**WARRANTY  
BULLETIN**

Wb04-07

<b>DATE : SEPTEMBER 2004    SECTION : 07 - Transmission</b>
<b>EXPIRATION: SEPTEMBER 2006</b>
<b>SUBJECT : INSPECTION OF CLUTCH ACTUATOR AIR LINE ON ZF-ASTRONIC TRANSMISSION</b>

Figure 1: LOCATING THE CLUTCH ACTUATOR AND AIR LINE

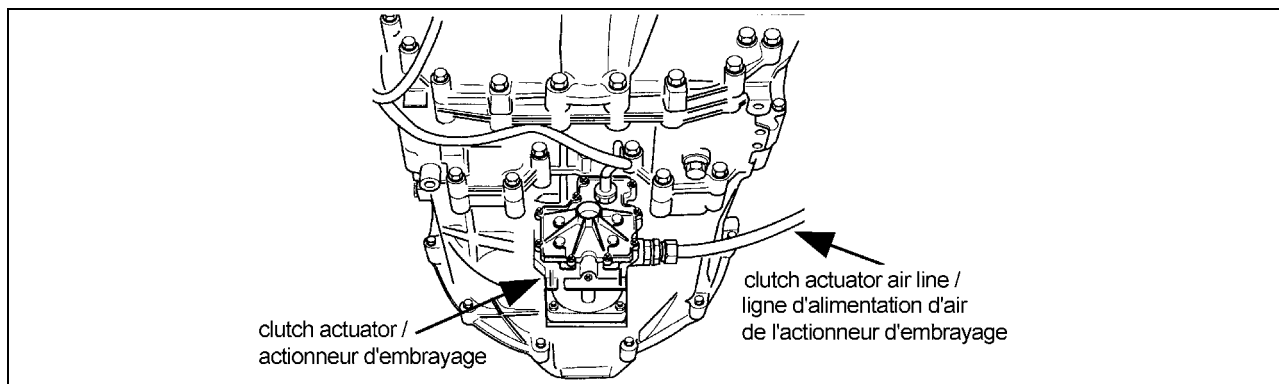
1. Under the transmission, locate the clutch actuator and the air line (Figure 1).
2. Inspect the clutch actuator air line up to the air tank (Figure 2) especially where the air line passes through the transmission protective panel. There is a risk of rubbing between the air line and the passing hole. Check for cuts, rub or abrasion marks on the nylon tubing.

3. If there is evidence of rubbing between the nylon tubing and the transmission protective panel, perform the corrective measures of part B.
